Recall Campaign Bulletin

Campaign No. 2023070012, September 2023

SUBJECT: **Model Various Models**
Model Year 2021-2023

Replace Fuel Pump Delivery Module

Figure 2 (release corresponding connector and disconnect the contacts)

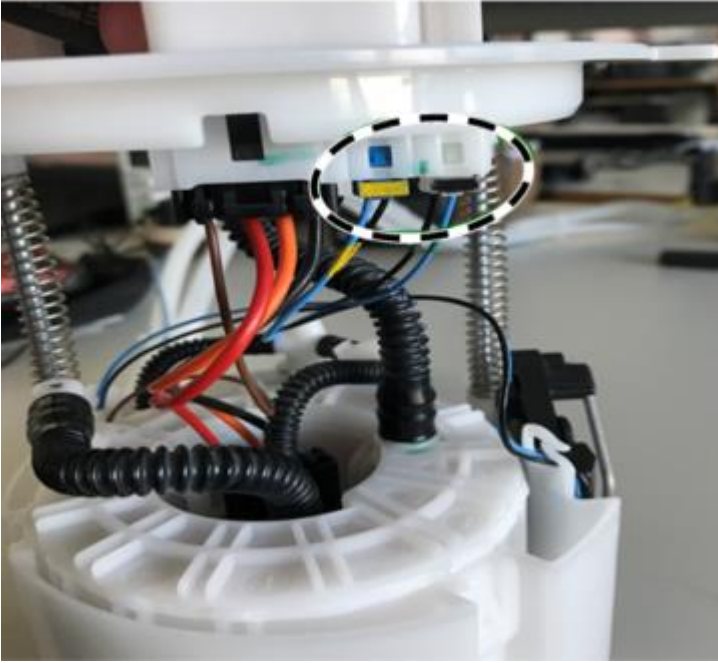
i Delivery modules that are delivered **without float-and-lever sensor** must be modified. **(Figure 2-4)**

Figure 3 (remove lines from routing clip)

Figure 4 (using a screwdriver, carefully push float-and-lever sensor housing away from module housing and at the same time push float-and-lever sensor housing upwards.)
